DEVELOPER: SEGELKE REAL ESTATE, LLC AND/OR MPCOS, LLC
COLORADO SPRINGS MY PLACE HOTEL

CIVIL COVER SHEET C000

SITE DEVELOPMENT PLAN

Rev.	Date	Comment
A	9.27.17	PLAN REVIEW COMMENTS

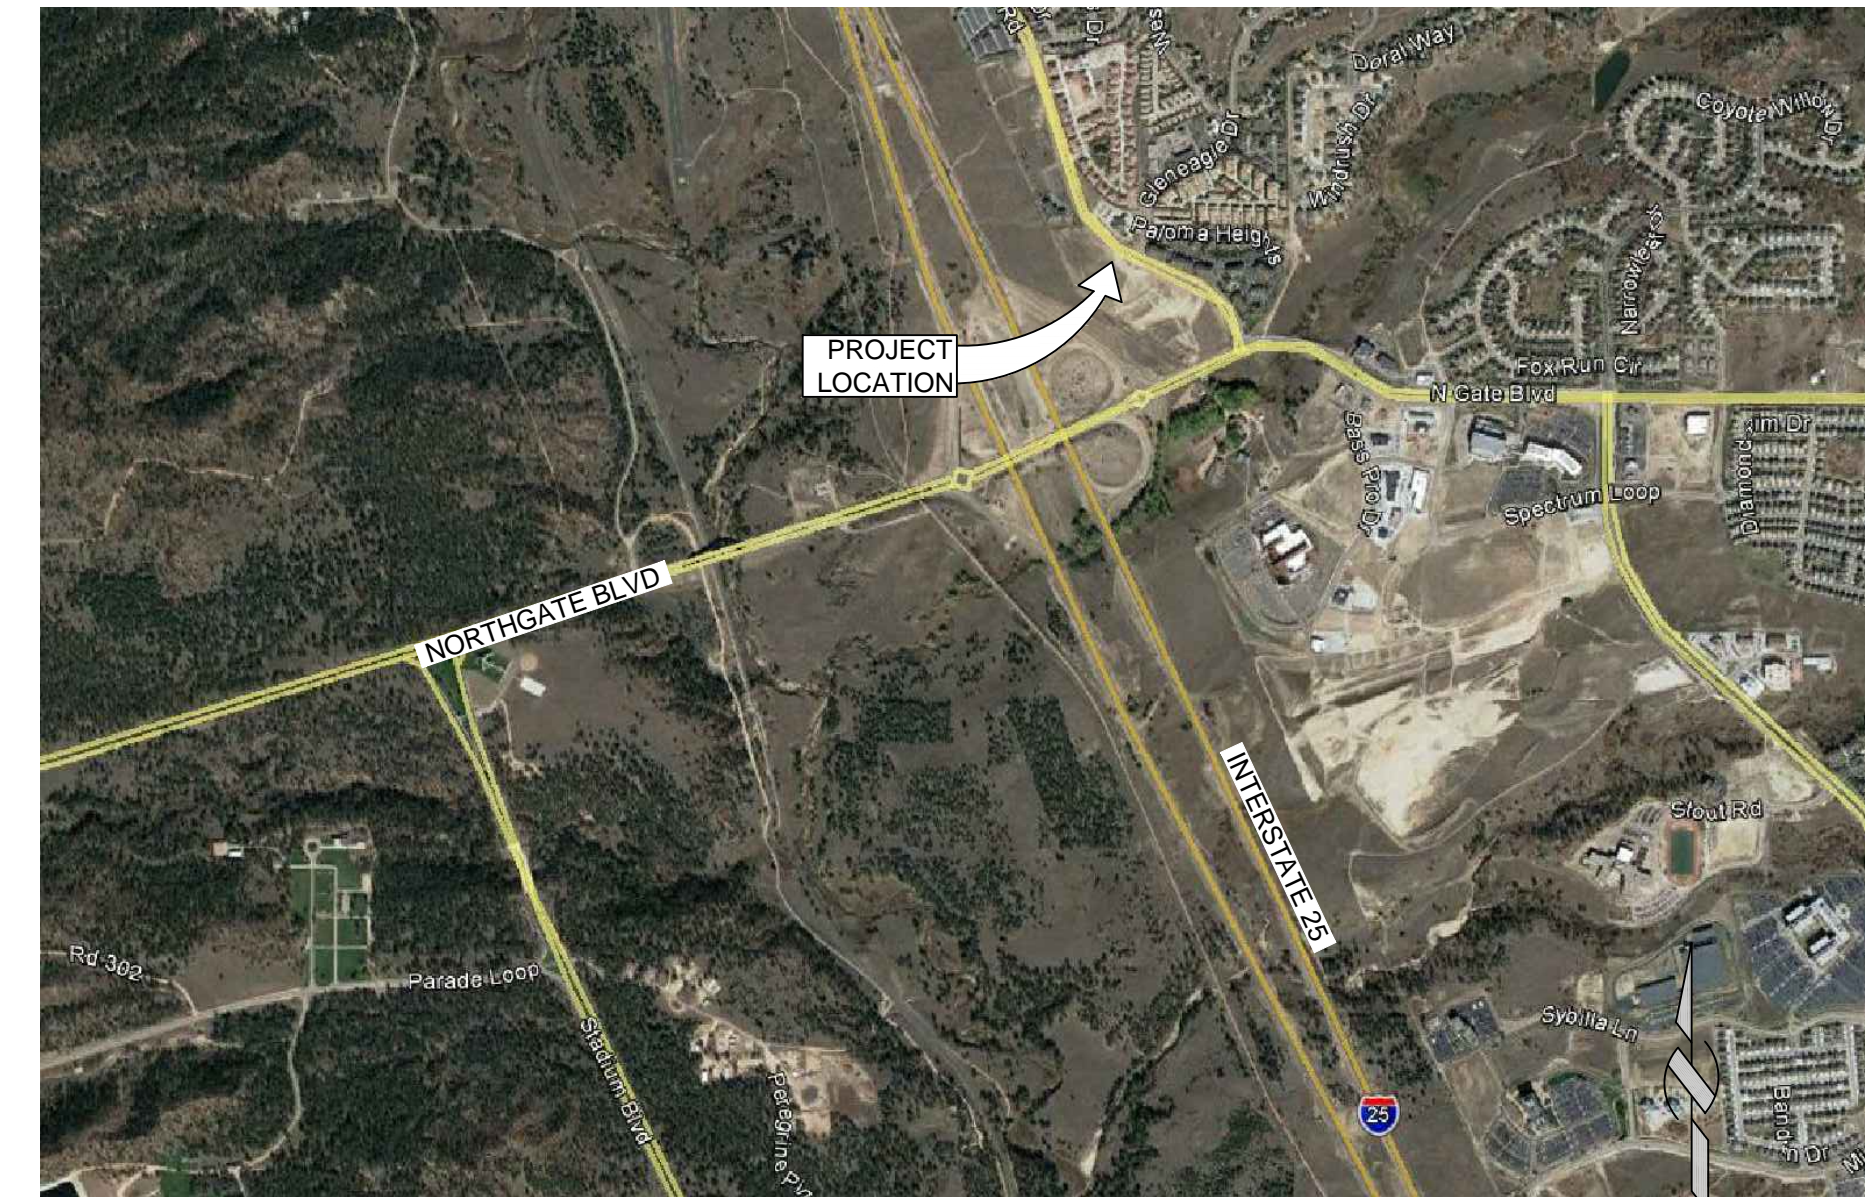
EL PASO COUNTY:
PLANNING AND COMMUNITY DEVELOPMENT
2880 INTERNATIONAL CIRCLE
COLORADO SPRINGS, CO 80910
MR. JEFF RICE
719.520.6300
Delete Jeffs name please

GRADING PLAN C300

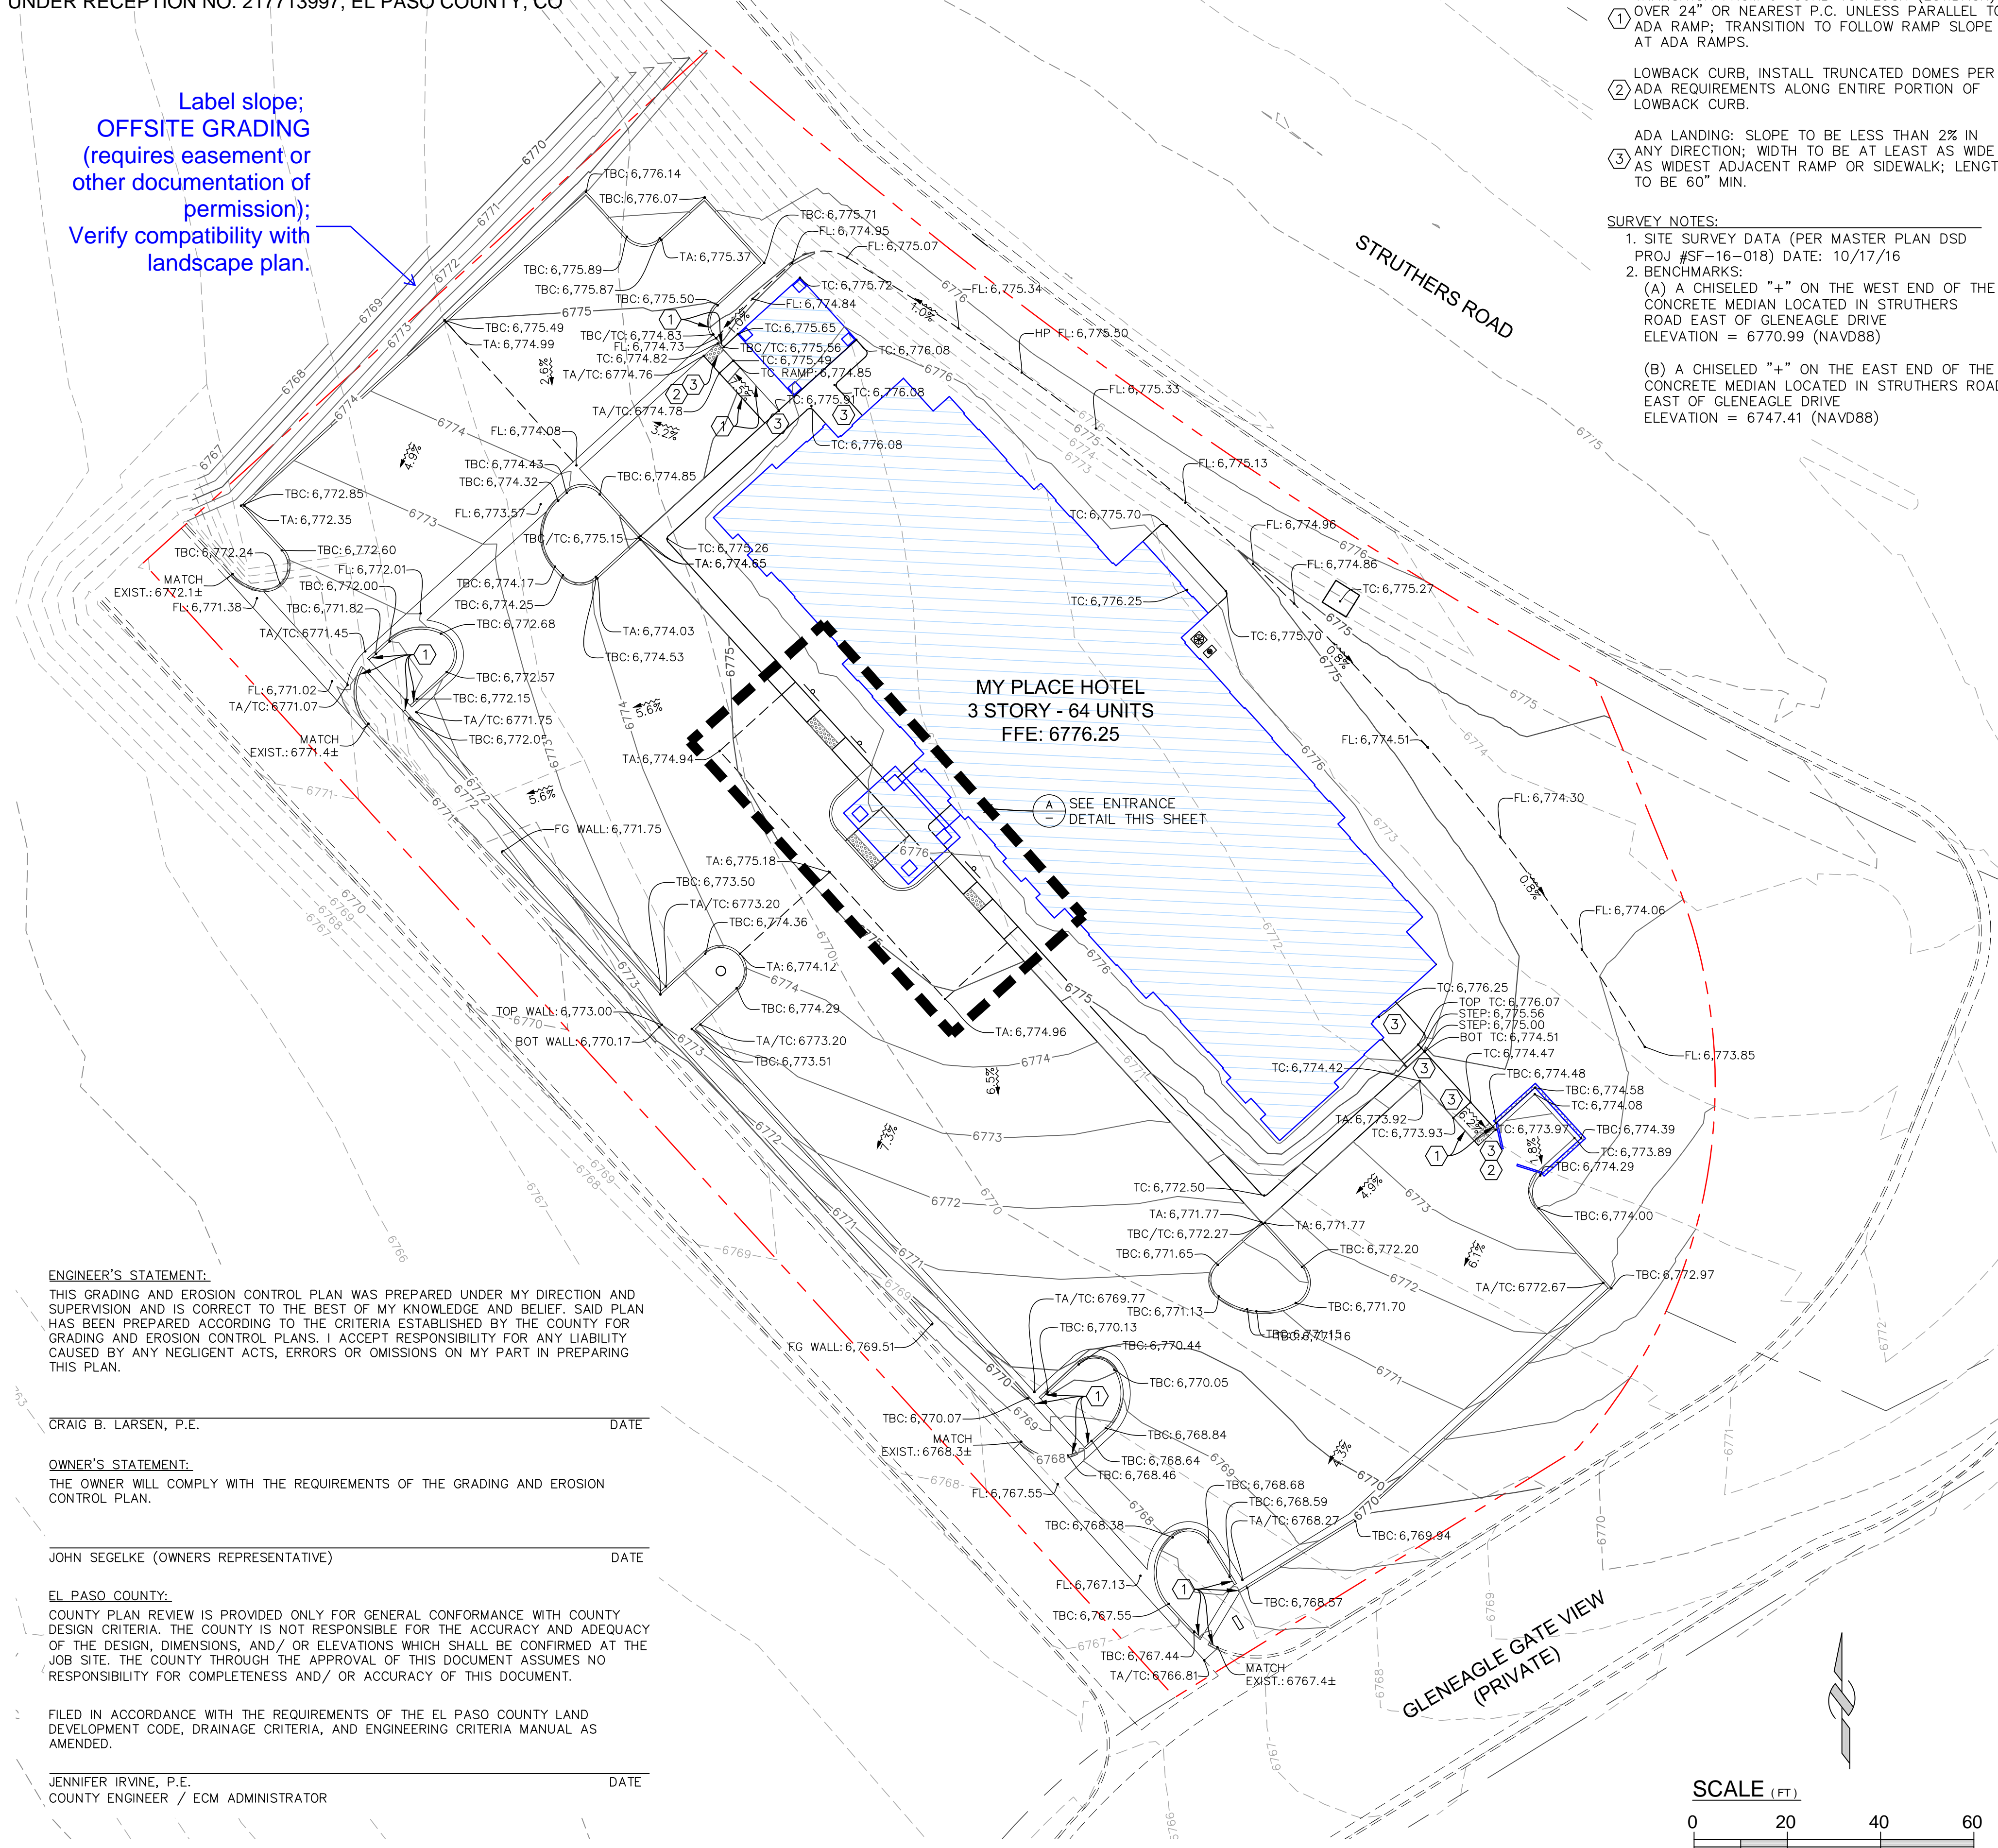
Label slope;
OFFSITE GRADING
(requires easement or
other documentation of
permission);
Verify compatibility with
landscape plan.

EROSION CONTROL PLAN C400

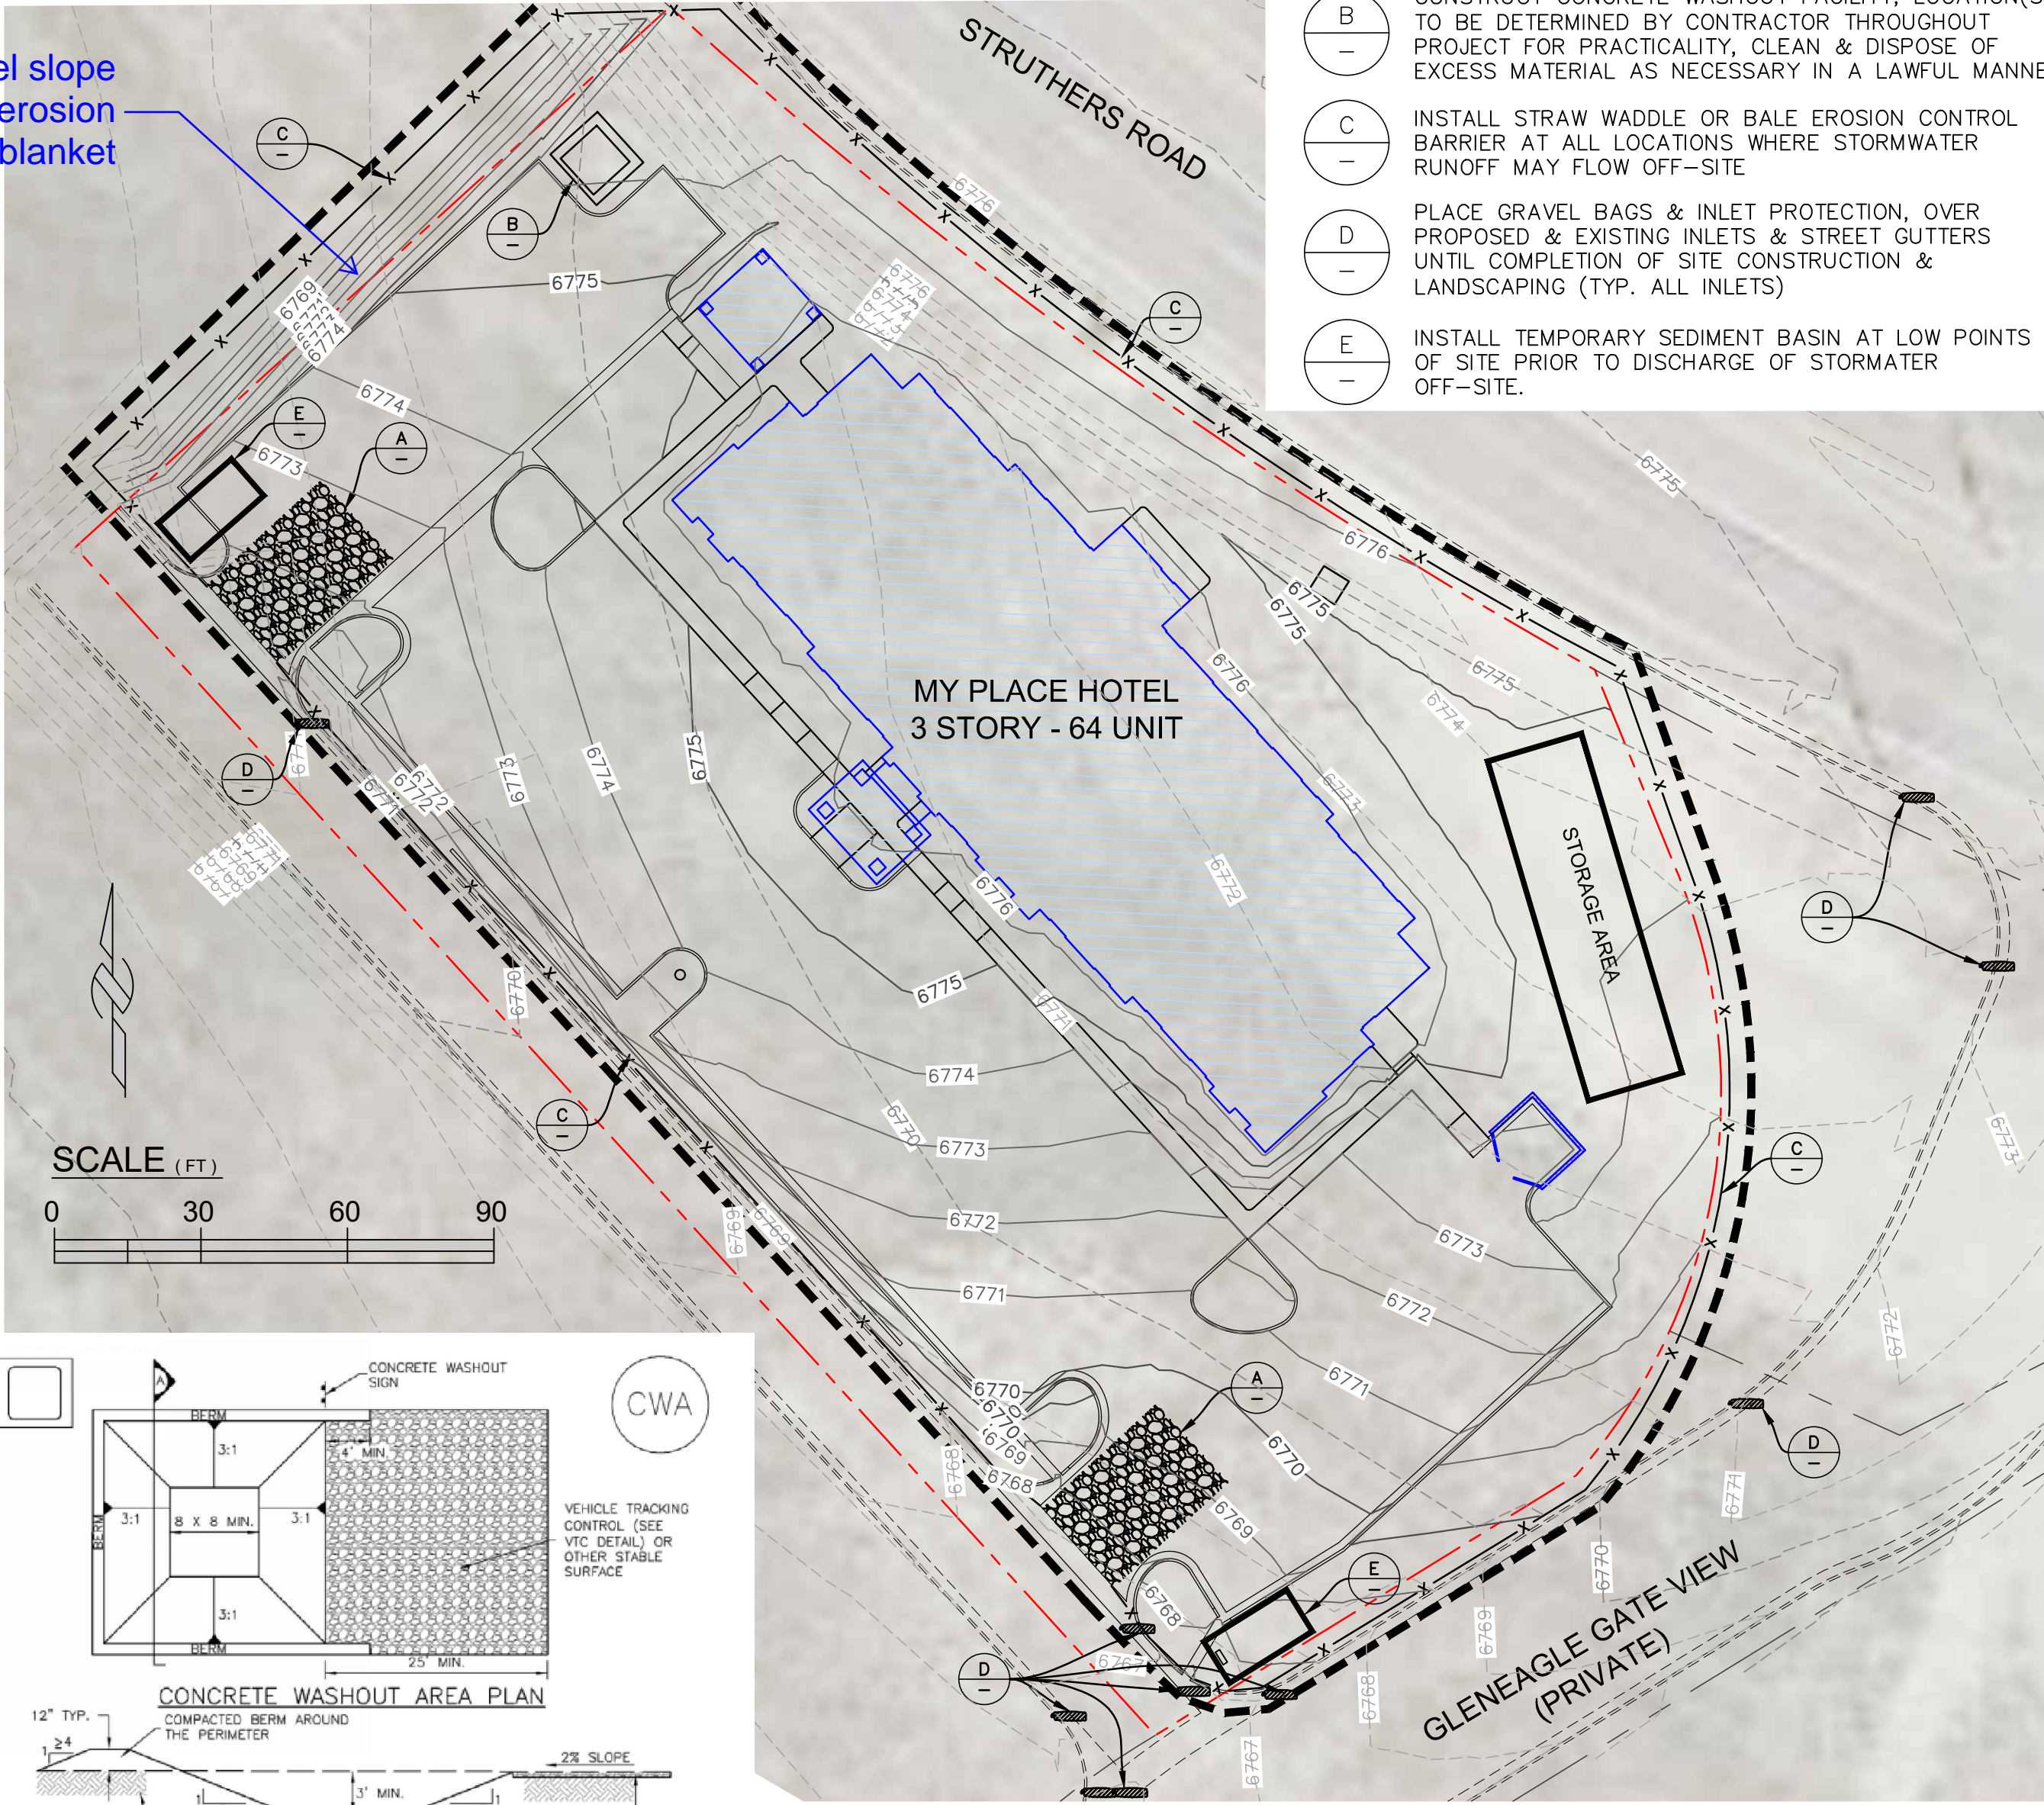
Label slope and erosion control blanket

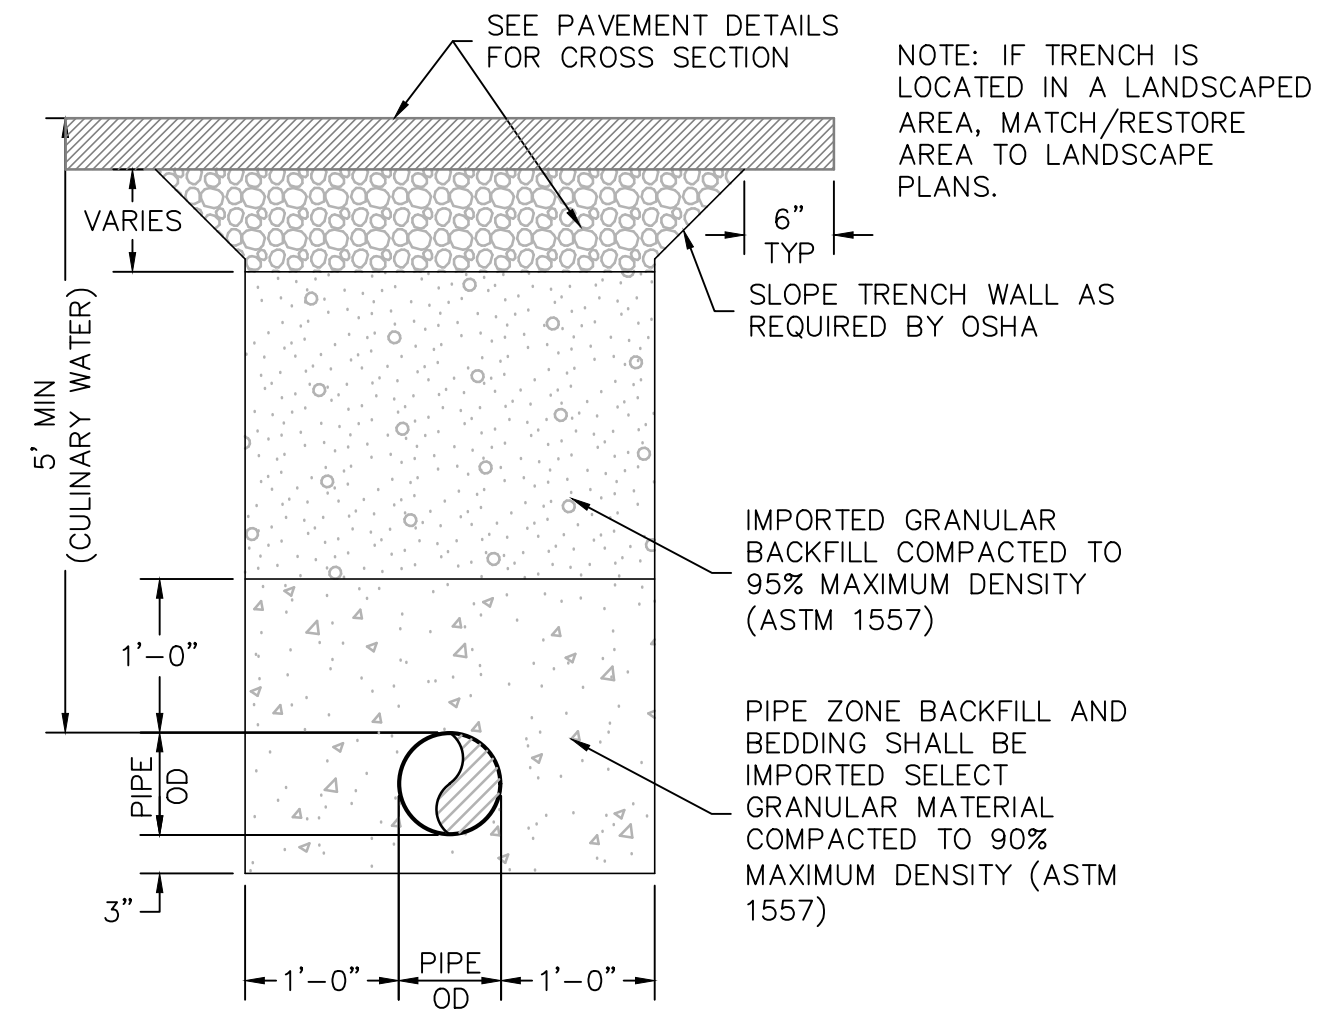
- Add ECB detail
